Section 4.55(1A) Application for Modification - Substation Arrangement (SSD 6339)

St Catherine's School, Sydney, 26 Albion Street, Waverley

Modification Report to
NSW Department of Planning, Industry and
Environment and Public Spaces

21 April 2021 | 1330

Figure 4 – Section 4.55(1A) Proposal: RPAC Level 4 Phase A (Source: 4.55(1A)103_B)

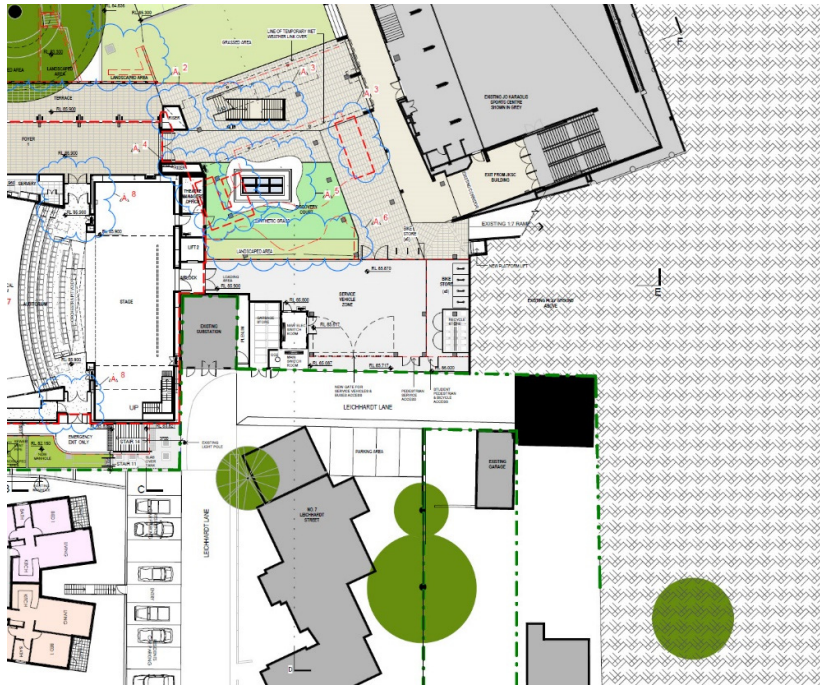
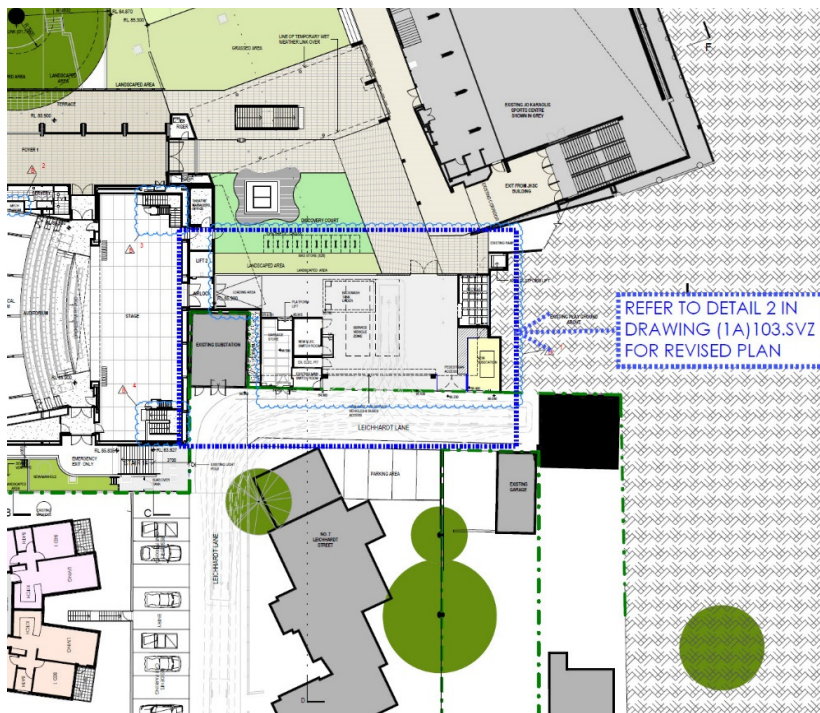
The original and modified substation arrangements are illustrated by **Figures 3 to 6**.

1. CO2 room deleted as no longer required
2. Vehicular gate swing doors replaced by roller shutter for a more adequate and safe circulation entry/exit of vehicles
3. Internal fence & associated gate deleted as no longer required
4. Pedestrian gate relocated for improved functionality
5. New substation relocated from Albion Street to Leichhardt Lane
6. Recycle store relocated for improved facilities operations and functionality

7. Internal gate enlarged and relocated for better access of emergency/service vehicles
8. Bike store relocated¹
9. New access point to garbage store improved facilities operations functionality

10. Existing electrical pit area to remain for serviceability
11. New electrical switch room enlarged for compliance
12. Access steps provided to save levels difference

Figure 7 – Comparison of Original Consent and Section 4.55(1A) Proposal: East Elevation (Source: (1B)150.SVZ_A)

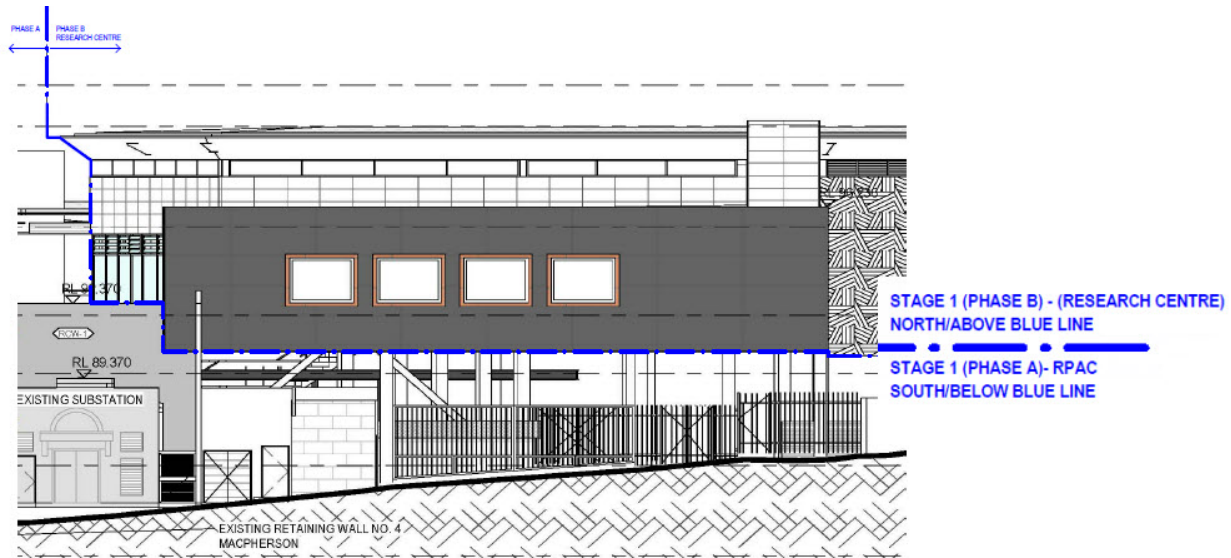
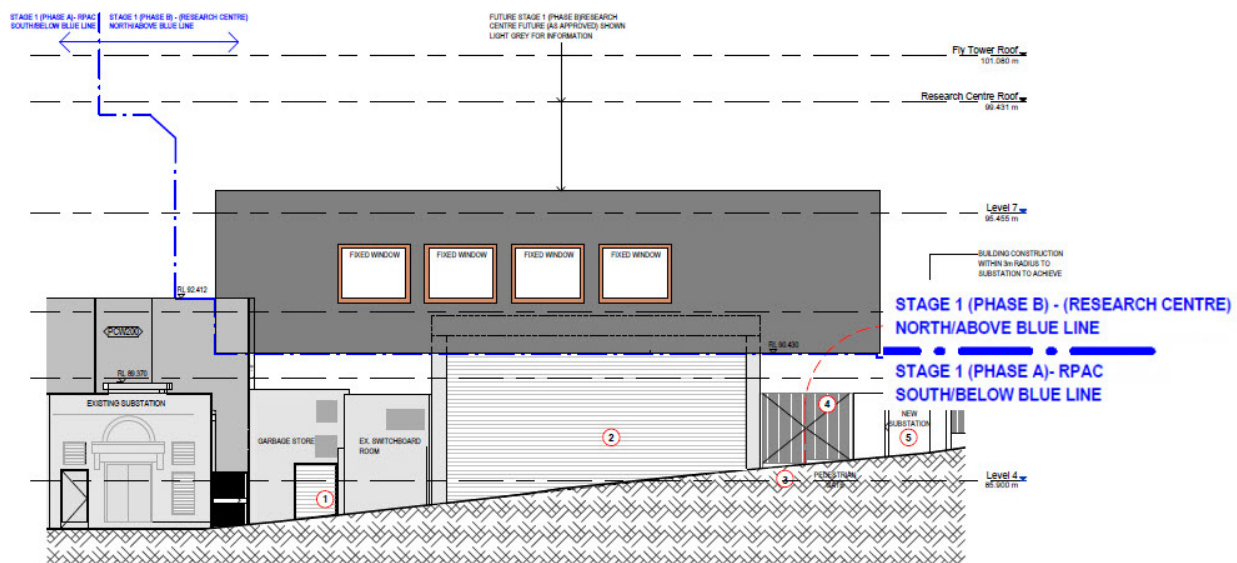
16. Revised service vehicle zone for improved area functionality
17. Revised extent of mechanical plant to reflect final design
18. 3. New screening to mechanical plant to comply with conditions of consent

19. Revised extent of natural and mechanical ventilation louvres for internal space amenity compliance
20. Revised roof RL to achieve minimal falls and insulation requirements

24. Revised top of wall RL for blast protection to achieve compliance with AUSGRID requirements
25. Landscape plan modifications arising from the changes to the Architectural Plans.
